AGENDA

Limestone Coast Southern Regional Assessment Panel 18 April 2024

6 REPORTS**6.1 DA:24002968 - REVIEW OF DECISION - 44 ST ANDREWS DRIVE, WORROLONG – REPORT NO. AR24/25065**

Development No:	DA:24002968
Applicant:	Empak Homes
Property Address:	44 St Andrews Drive, Worrolong
Property Owner:	Mr Gordon Clark & Mrs Vicki Clark
Report No:	AR24/25065
CM9 Reference:	AF22/276
Author:	Roslyn Snaauw, Senior Planner
Authoriser:	Tracy Tzioutziouklaris, Assessment Manager
Nature of Development:	To construct a detached dwelling
Description:	To construct a detached dwelling
Zoning:	Golf Course Estate
Policy Area:	City of Mount Gambier
Heritage:	N/A

Figure 1: Proposed site plan

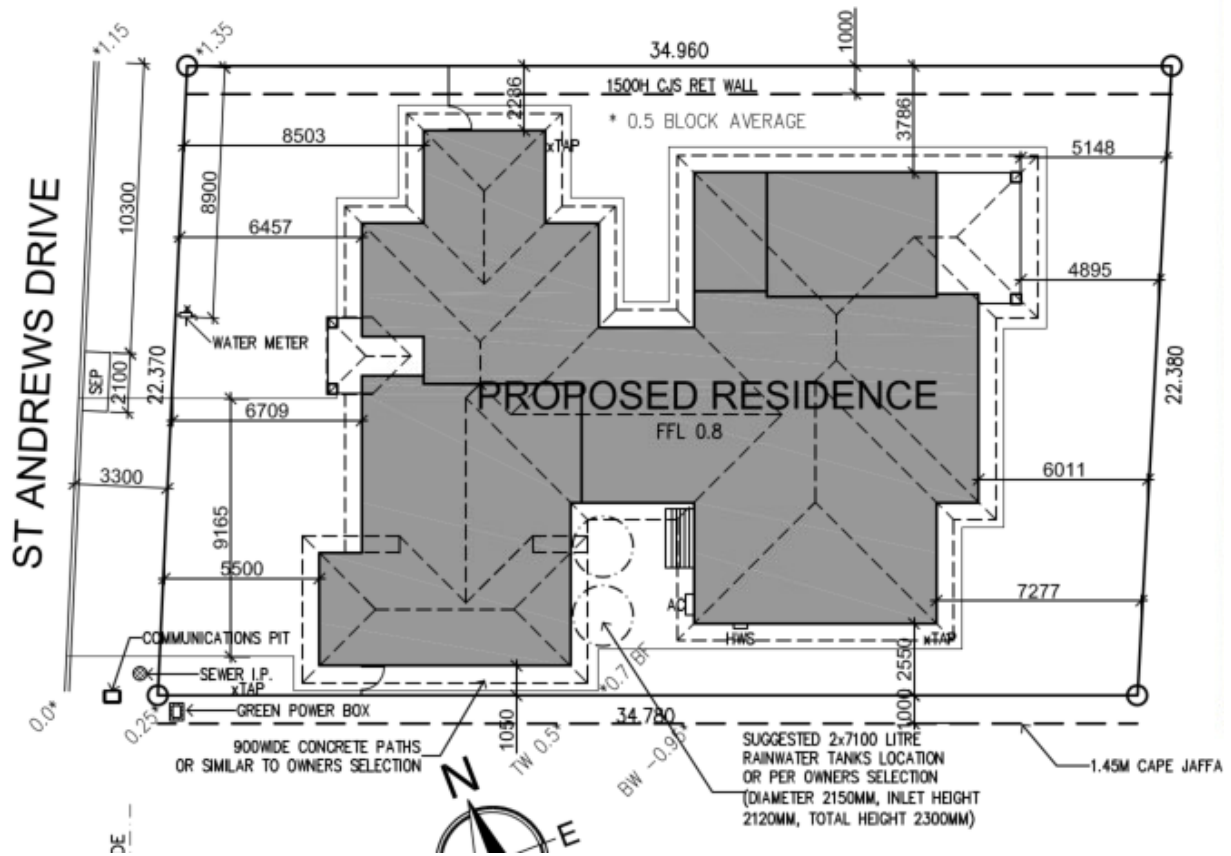
The minimum primary street boundary setback of the proposed development is 5.5 metres to the garage with the proposed dwelling setback a minimum of 6.45 metres. Council note that the garage is not located in line or behind the building line of the dwelling (Part 4 - General Development Policies – Garage appearance – PO 14.1) which Council does not support as an acceptable design, detracting from the streetscape and the appearance of the dwelling. This will be discussed further below in this Report.

The proposed garage is proposed to be constructed 1.5 metres in front of the building line of the dwelling (porchs do not form part of the building line as detailed in the Code as detailed earlier in this Report).

Figure 2: Proposed floor plan

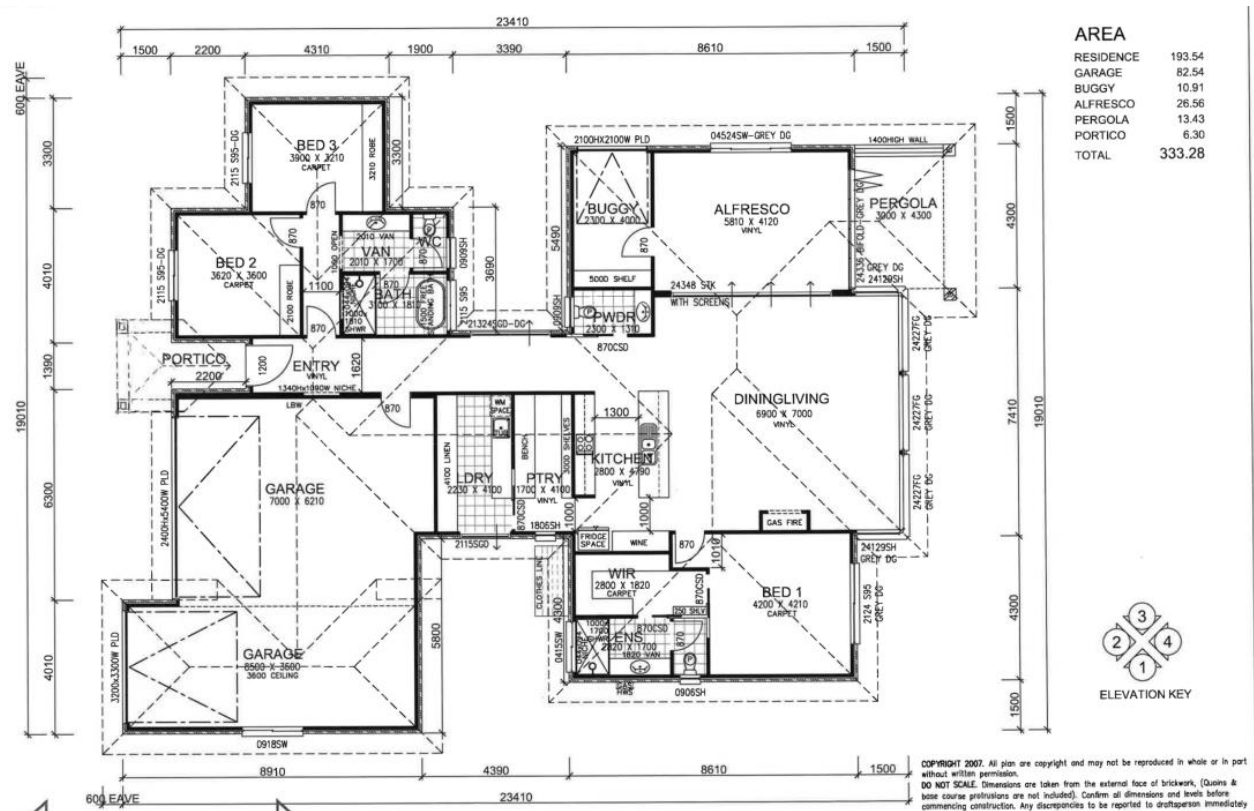
The garage panel lift doors will have a width of 5.4 metres plus 3.3 metres totalling a width of 8.7 metres.

The dwelling is one level and the length of the proposed western elevation of the dwelling is 19.0 metres. The proposed garage door opening will be greater than 50% of the western elevation.

Figure 4. Western Elevation of proposed dwelling

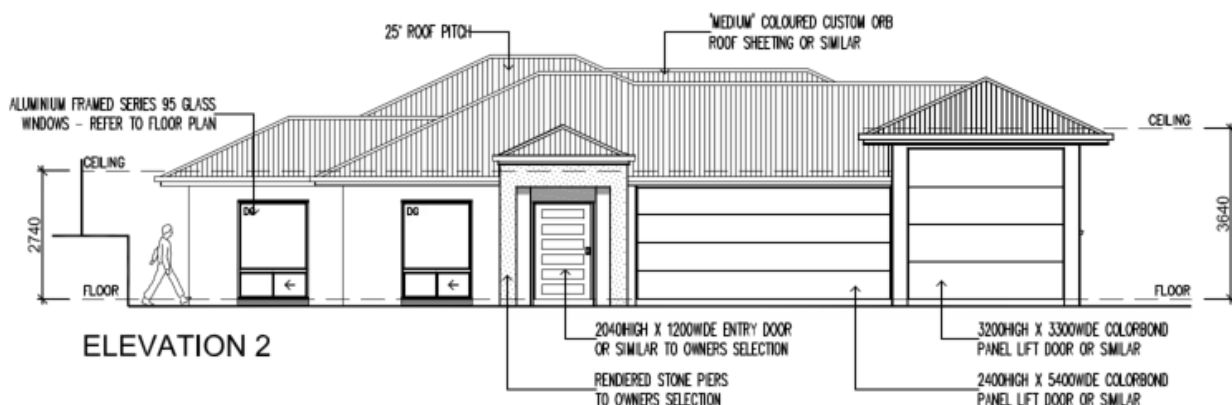
The location of the garage forward of the building line will detract from the streetscape and appearance of the dwelling as can be seen in the elevation plans provided with this application.

Council consider that the proposed garage location does not respond to its surrounding built form and is not contextual by considering, recognising and carefully responding to its natural surroundings or building environment and positively contribute to the character of the locality. Examples of other garages and also same façade – but not setbacks of what is being proposed, are not forward of the building line within the immediate neighbourhood character.

Council advised the Applicant that this proposed development would be out of character with the neighbourhood character and suggested amending plans to show the garage not to be in front of any part of the building line of the dwelling. The applicant provided an amended site plan showing the porch area being increased.
